**RE: APPROVAL WITH MODIFICATIONS
CLOSURE PLAN FOR THE AERATION LAGOONS
WESTERN REFINING SOUTHWEST, INC., BLOOMFIELD REFINERY
EPA ID # NMD089416416
HWB-GRCB-07-006**

The New Mexico Environment Department (NMED) has reviewed Western Refining Southwest, Inc., Bloomfield Refinery's (Western) *Closure Plan North and South Aeration Lagoons* (Closure Plan), dated May 2008. NMED hereby approves this Closure Plan with modifications. Western must adhere to all requirements established below.

Giant Bloomfield Refinery
 Area Plot Plan
 Recovery Well & Monitoring
 Well Locations

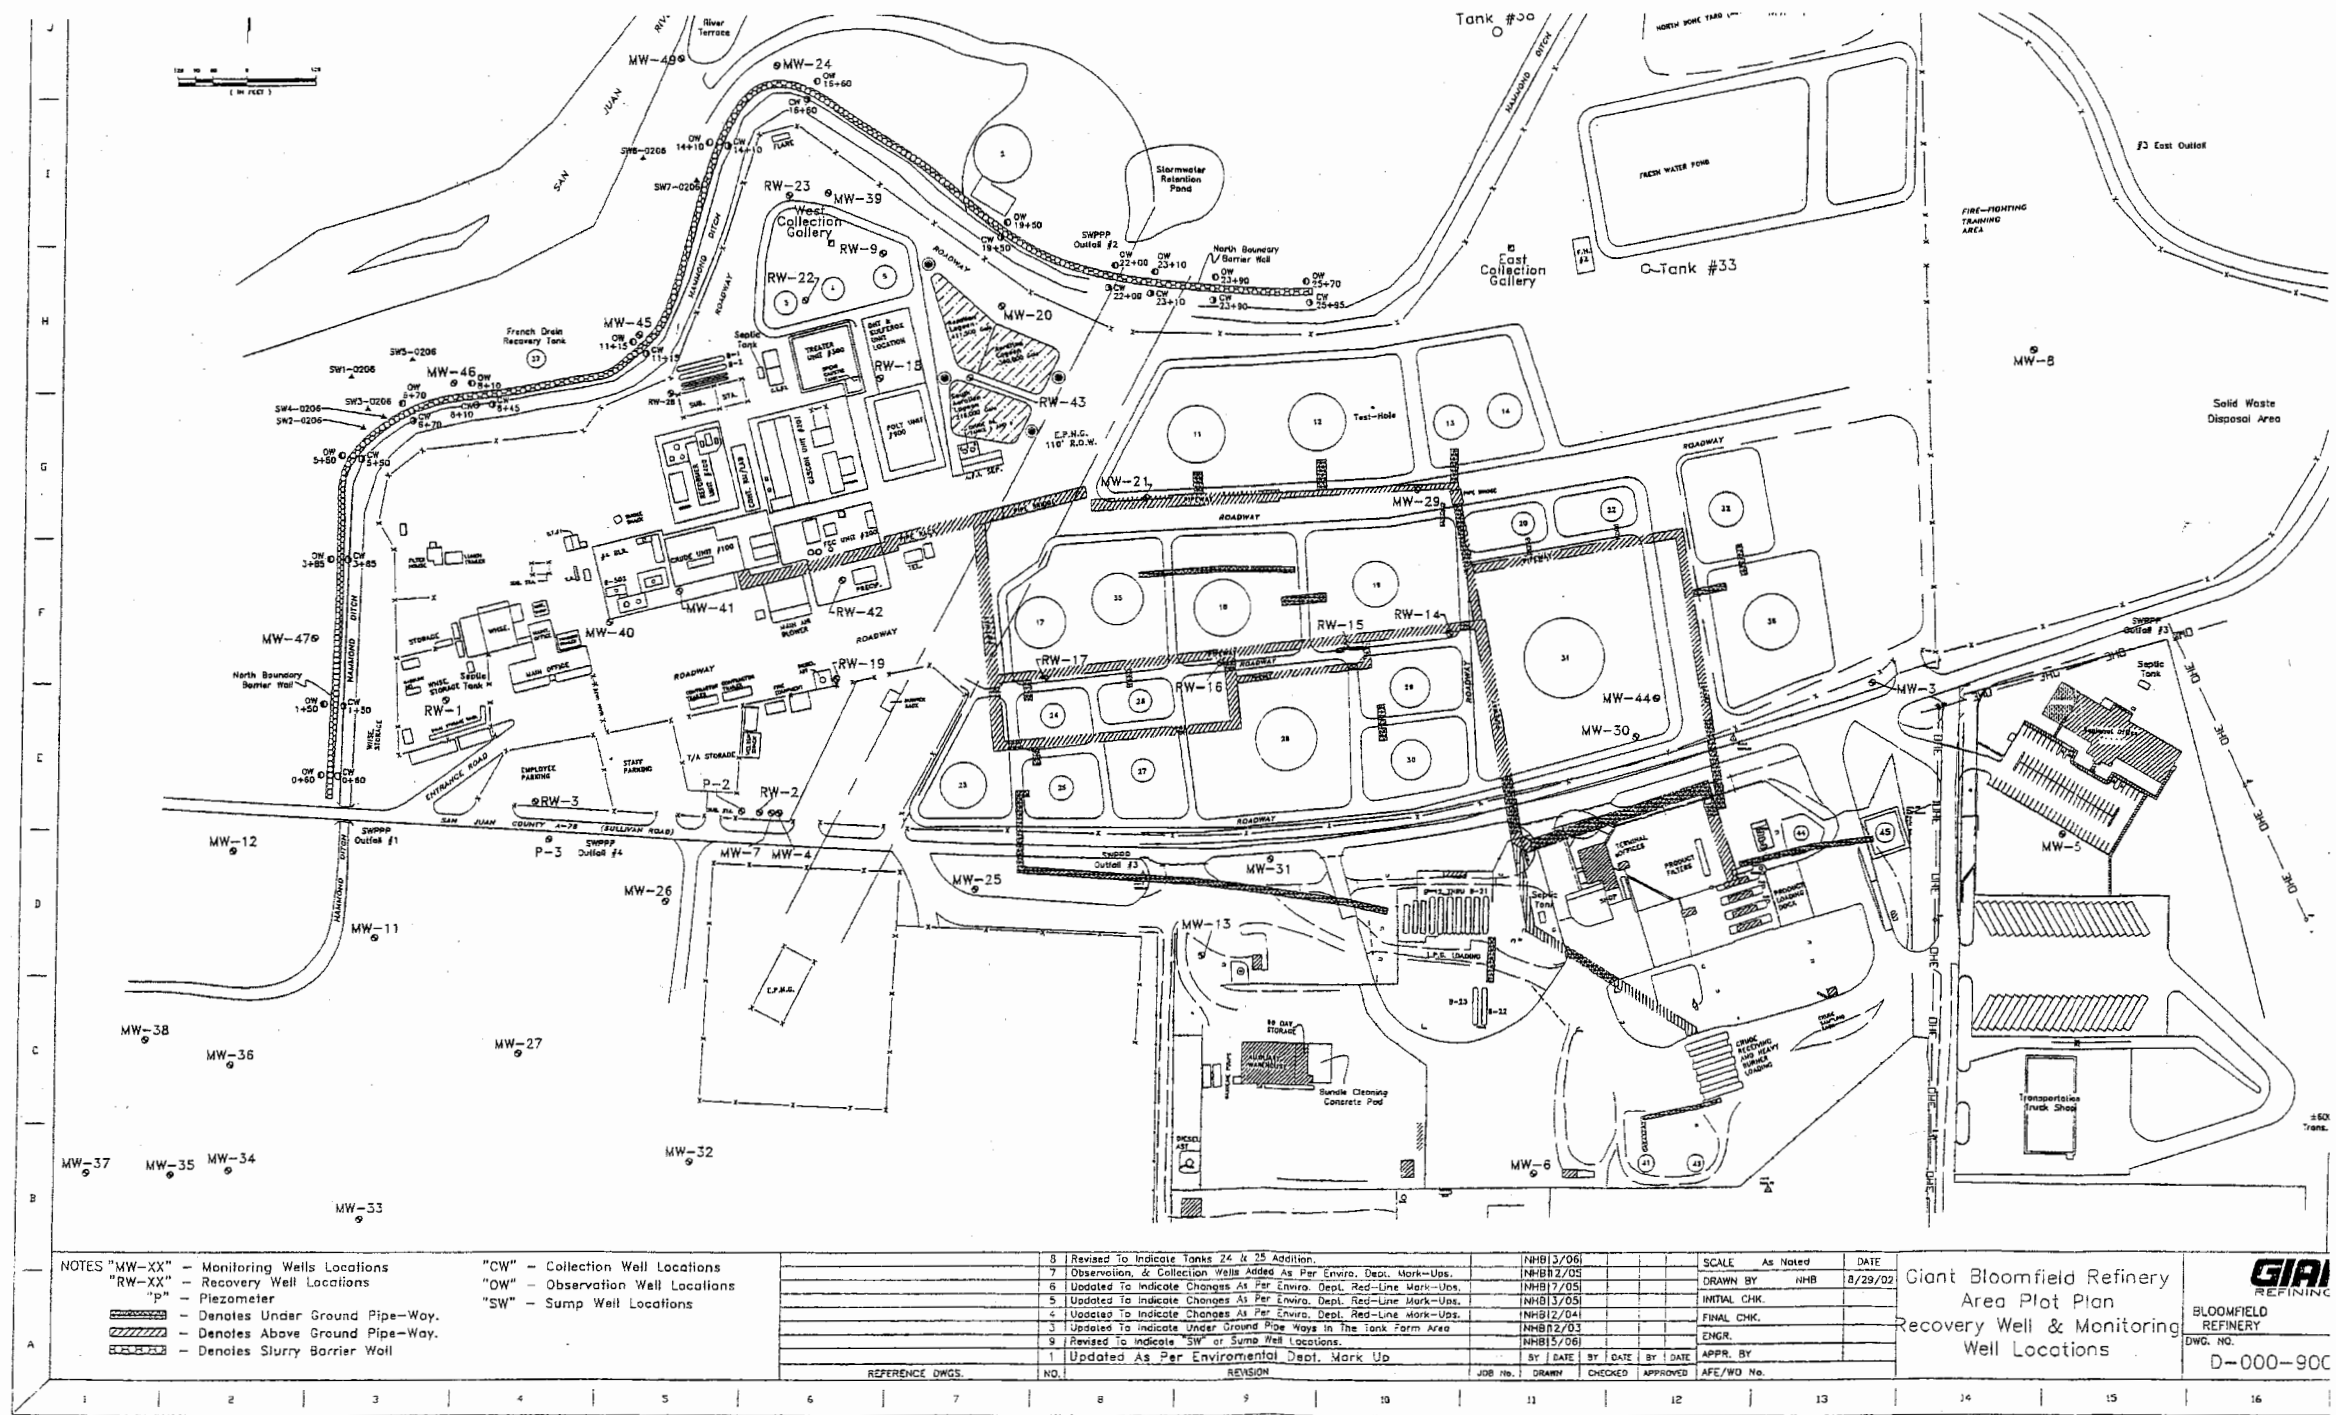
As part of the closure process, Western must install the four monitoring wells at the locations identified in the attachment Figure 1 (refer to 40 CFR 264.112(b)(5)) and must adhere to the following:

- a. Western must follow the Monitoring Well Construction Requirements located in Section IX of the Order.
- b. The well screen must be approximately 15 feet in length, intersect the water table with approximately five feet of screen above the water table and approximately 10 feet of screen below the water table.

- d. Groundwater samples must be collected from the four newly installed monitoring wells no later than five days after the completion of the well development. The samples must be analyzed for DRO extended, GRO, VOCs, SVOCs, RCRA metals, and general chemistry to include major cations and anions. When sampling, Western must follow the applicable requirements found in Section VIII.B (Groundwater and Surface Water Monitoring) of the July 27, 2007 Order.

- e. Since closure of the Aeration Lagoons will begin 60 days after NMED’s approval, the monitoring wells must be installed 180 days from the day closure begins. Western must contact NMED one week prior to the start date of closure.
